Engineering Staff Comments

**SOUTHBROOK CHURCH
PROPOSED PHASE-I - ADDITION & ALTERATIONS
FRANKLIN, WI**

1 LIGHTING PLAN
 E2.0 1/4\"/>

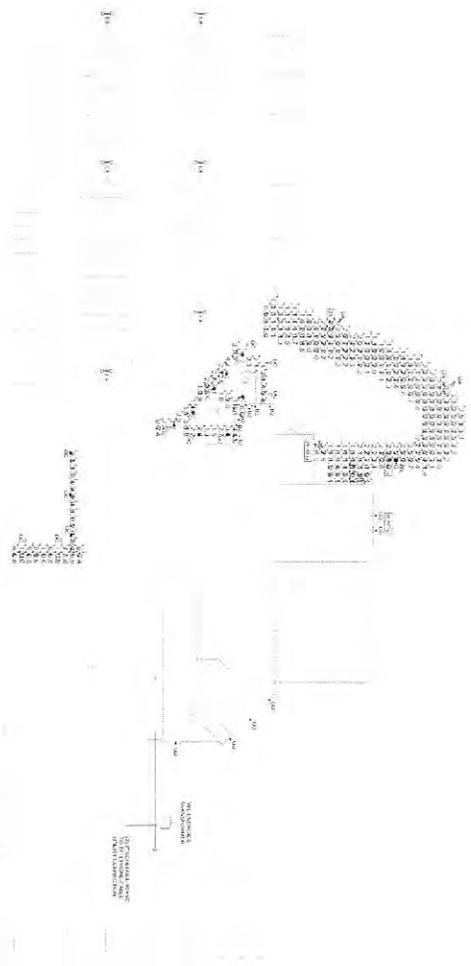
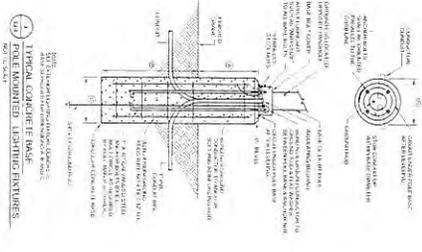
20. Please rename the Electrical Site Plan (Sheet E2.0) to Lighting Plan.
- Sheet E2.0 has been re-named as requested.
 - Scope of site lighting has been decreased due to budget limitations.

- Information has been provided as requested.
22. Please add the mounting height of the proposed luminaires to the Lighting Plan in accordance with Section 15-5.0402(B)(3) of the UDO.

- Mounting heights have been indicated on sheet E2.0 as requested.
23. Please indicate the illumination levels (in footcandles) at the property boundary lines on the Lighting Plan, in accordance with Section 15-5.0402(B)(3) of the UDO. Alternatively, Staff would accept showing the property boundaries on the Lighting Plan and only depicting the illumination levels until they reach zero foot candles.

FLOOR PLANS SHOWING PROPOSED PHASING

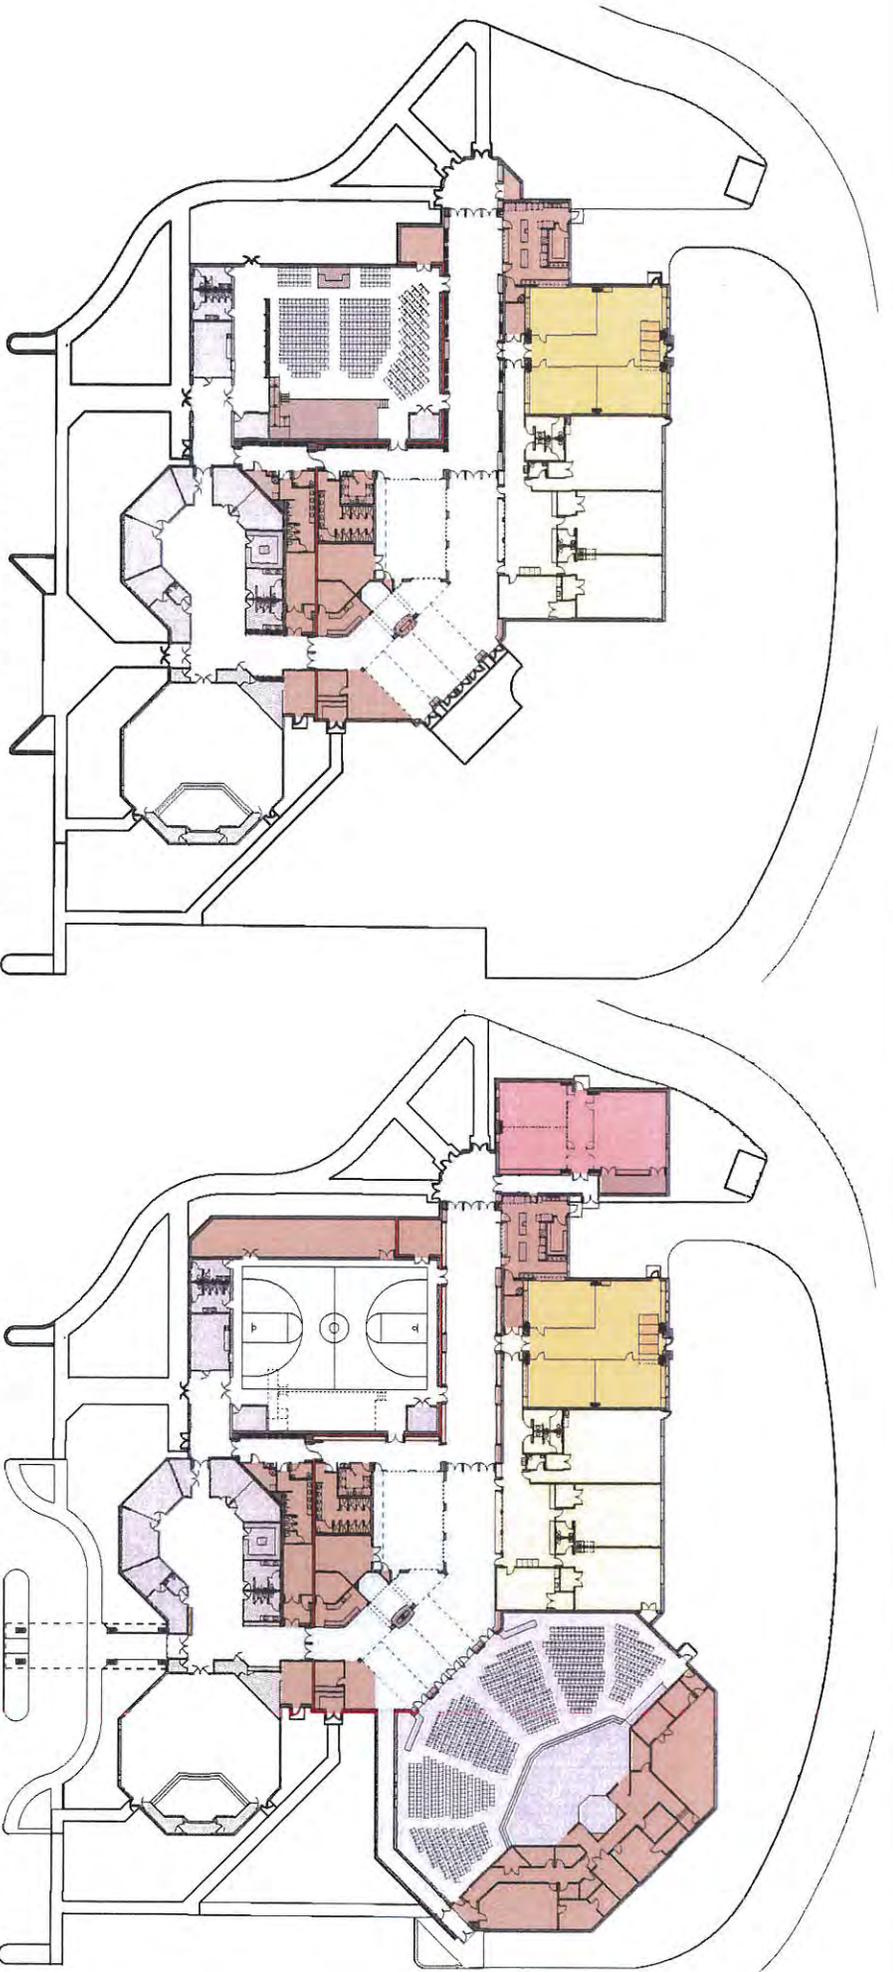
19. Please either include the Conceptual Design and Mater Planning Overall Site Plan and associated artist's renderings previously shared with Staff along with your Site Plan Amendment submittal, or address how the Future Phase II additions affected the choice of building materials/design of the East, Northeast and West Elevations of the proposed addition in a revised Project Narrative.

- The Conceptual Future Phase-II Additions have been indicated, as requested, on the Overall Site Plan, Floor Plans, and exterior renderings of the building. We understand that these will be useful in evaluating how the Owner is currently contemplating further expanding the building in the future. However, we would like to stress that ONLY the proposed Phase-I plan is currently being submitted for review/approval, and that the Conceptual Future Phase-II drawings will require considerable review and modification if/when the Owner is in a position to undertake a future expansion project. It is POSSIBLE that programming needs may have changed considerably by that point. The information depicted here-in is based on current assessment of anticipated future need.

BUILDING ELEVATIONS

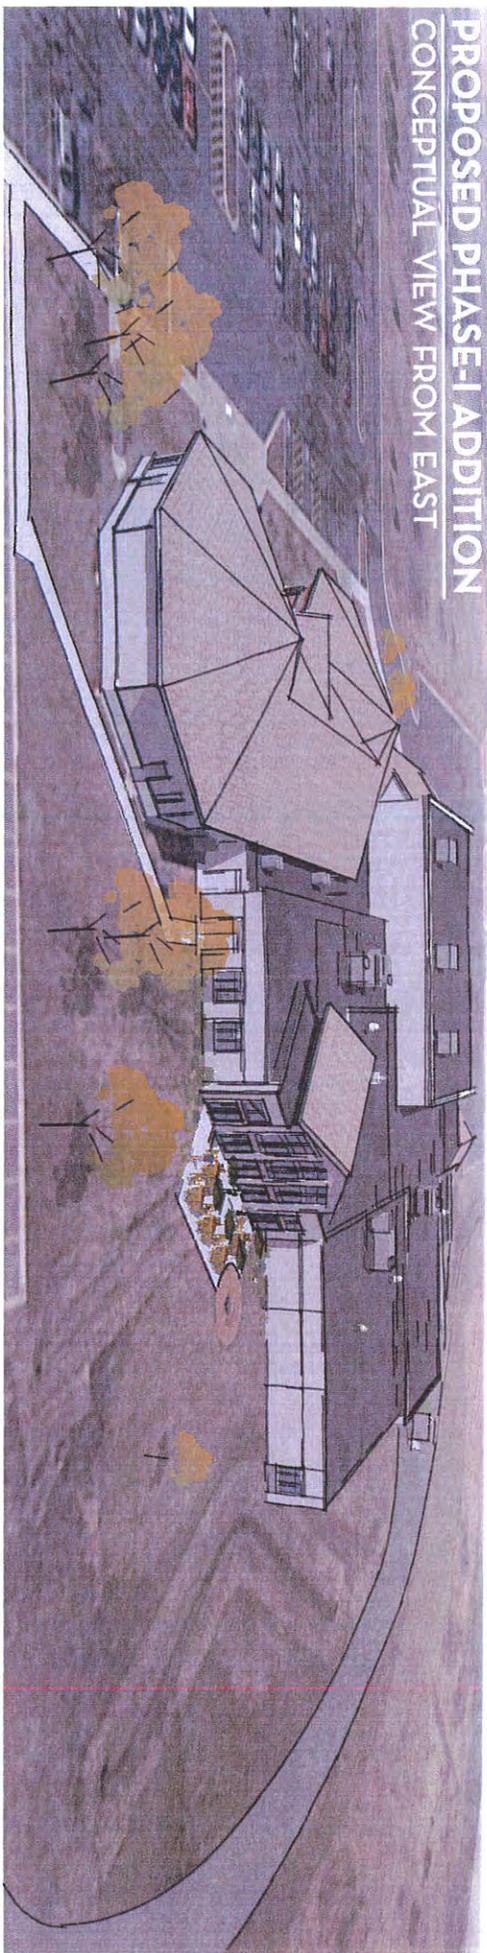
12. Staff suggests adding some 8” decade block in “Alexian Blend”, accent panels, or other architectural design treatment to the portion of the northeast elevation not affected by Future Phase II additions, as this elevation is dominated by the cedar/HardiePlank siding.

16. What is material 14 on the Exterior Elevations (Sheet A5.1)? In the Project Narrative this material is described as vertical accent siding, but on the elevations it appears to be E.F.I.S.

- The northeast elevation is a significant aspect of the current project. It has a raised gable roof form and extensive windows that will provide a visual connection from the main Fellowship Area to the exterior and the plaza area during Phase-I, but will also become the connection to a potential future worship space addition. As such, considerable attention was given to the design of this façade. The Owner’s Building Committee reviewed numerous options for façade treatment and detailing, and feels that the current level of material use is best:

- The narrow strips of opaque material between the large windows and doors lost their elegance and simplicity when cluttered with additional materials.

- The forms and proportions of the northeast elevation have been carefully planned to make a simple but unified composition, and addition additional material did not complement this approach.

- Since the vocabulary of the Alexian Blend brick is associated with the entrances of the existing building, it seemed appropriate to maintain that language, and to just use the Alexian Blend brick at the new west entrance area.

- Adding the Alexian Blend brick in this location also requires thicker footings/foundations to further increase the cost for this potential change – please see cost-limitation reasons listed above.

- At the remainder of the north elevation, CMU and additional Alexian Blend brick were reviewed and rejected for all the reasons stated in item # 11 above.

- Material #14 on the Exterior Elevations is an accent panel of a darker gray vertical siding. The stippled hatch used previously has been replaced with a hatch-pattern more indicative of the vertical siding.

H.V.A.C. ROOF-TOP UNIT DIAGRAM
N.T.S.

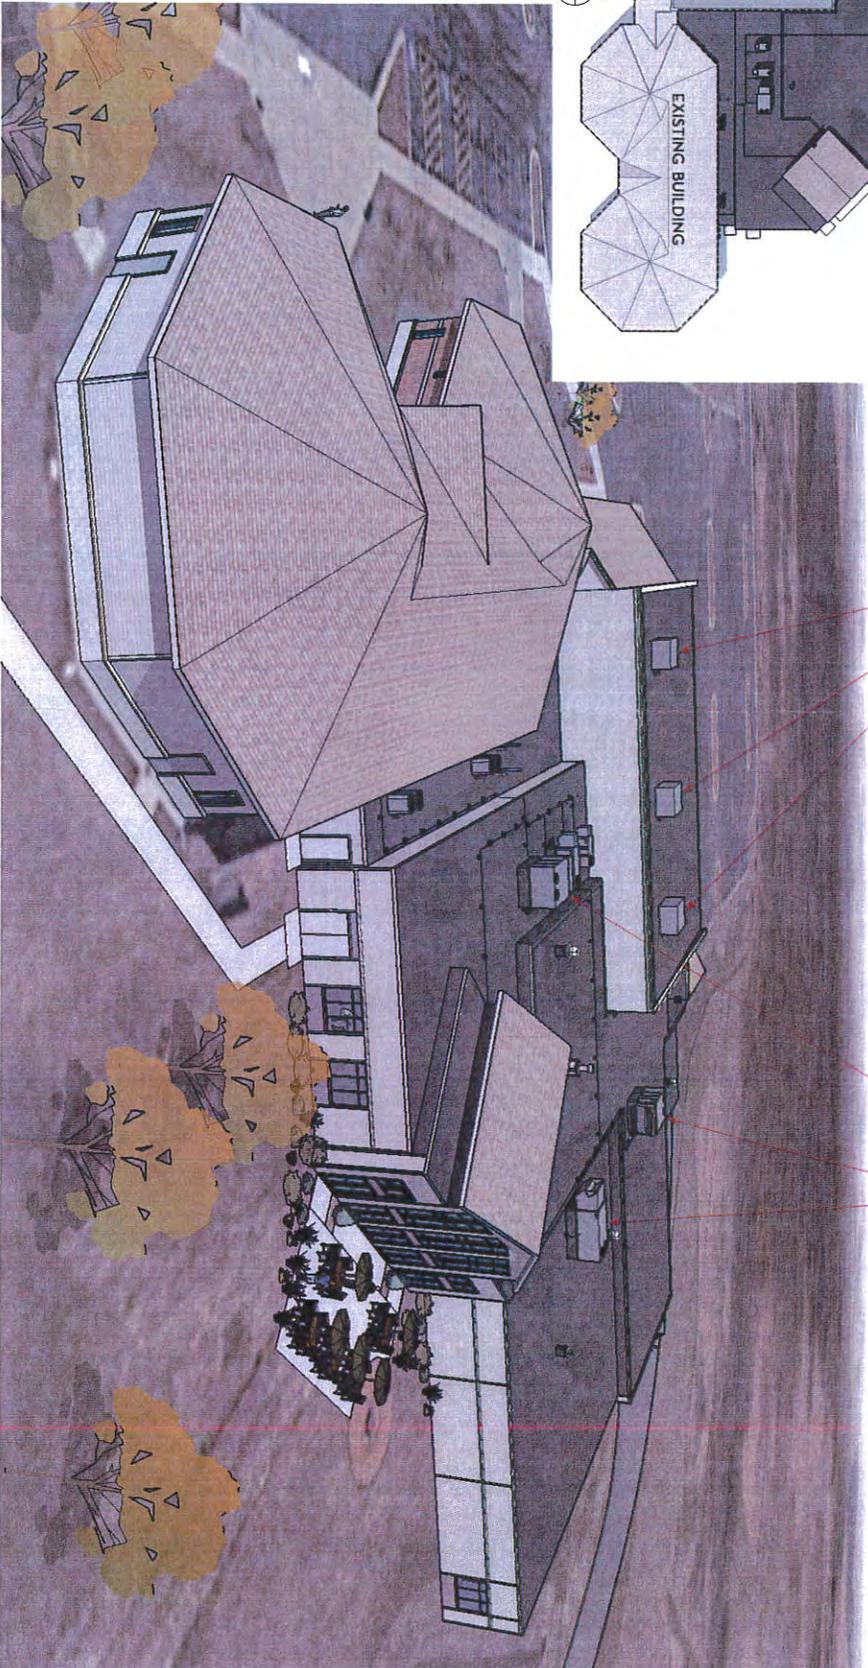
13. The proposed addition lacks parapet walls to screen the rooftop mechanical equipment. Therefore, Staff recommends screening the proposed roof top mechanical equipment with metal louvered or paneled screen walls. The existing three (3) pieces of rooftop mechanical equipment on the gymnasium are visible from the south side of the property. Therefore, Staff also suggests screening this existing rooftop mechanical equipment. Finally, Staff recommends showing the locations of the rooftop mechanical equipment on Architectural Site Plan (Sheet A2.0)

- The proposed Roof-Top Units (RTUs) have been shown on the Architectural Site Plan as requested. They have also been shown in the drawings in the 11x17 submittal package.

- For the new RTUs, since there is currently no ordinance language requiring screening, every effort has been made to position the new units to minimize their visual impact without additional screening:

- All the new RTUs are screened from the street by the existing building.
 - Most of the new roof-top mechanical equipment is on the lower roofs toward the middle of the building where they are hidden by the higher surrounding building massing.

- For the two RTUs serving the northern-most portion of the proposed Phase-I addition, they have been held as far from the exposed edge of the building as possible, and have higher mass of building behind them so that their silhouette against the skyline is minimized.
